**PUBLIC ADVOCATES OFFICE**  
**CALIFORNIA PUBLIC UTILITIES COMMISSION**

**REPORT ON PLANT PROJECTS  
FOR WHITTIER-LA MIRADA AND  
SATIVA SYSTEMS**

Suburban Water Systems  
General Rate Case Application 26-01-001  
Test Year 2027

## Figure 1-1: Inflation Calculation with US CPI Data

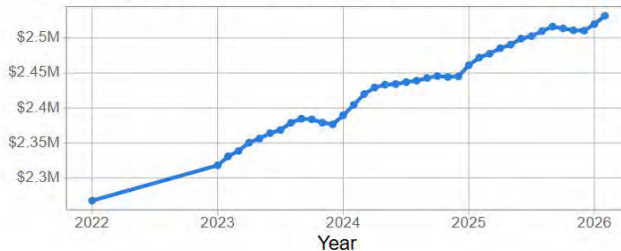
4         Additionally, Suburban’s cost to equip the production well at Plant 429 and to put  
5 extra piping to Plant 409 is not fully justified. In the prior GRC, Suburban’s estimated  
6 budget for well equipping was \$1,112,735 and piping to Plant 409 was \$1,154,650.<sup>20</sup> In  
7 this GRC, Suburban proposes \$5,343,413 for the same estimated work. That is an  
8 increase of approximately 147% within a rate case. Suburban claims the original project  
9 cost estimates were done in 2022, and since then construction-related inflation has  
10 increased significantly.<sup>21</sup> By using an online inflation calculator using the average  
11 consumer price index data, \$2,267,385 in 2022 is the equivalent of \$2,531,812 in 2026,  
12 factoring in inflation.<sup>22</sup> Please see Figure 1-1 below for calculation. Suburban’s request  
13 for \$5,343,413 to equip the new well and pipe towards Plant 409 is unreasonable.

**Result**   
**\$2,531,811.89** in Feb. 2026 equals \$2,267,385 of buying power in 2022 (Average).
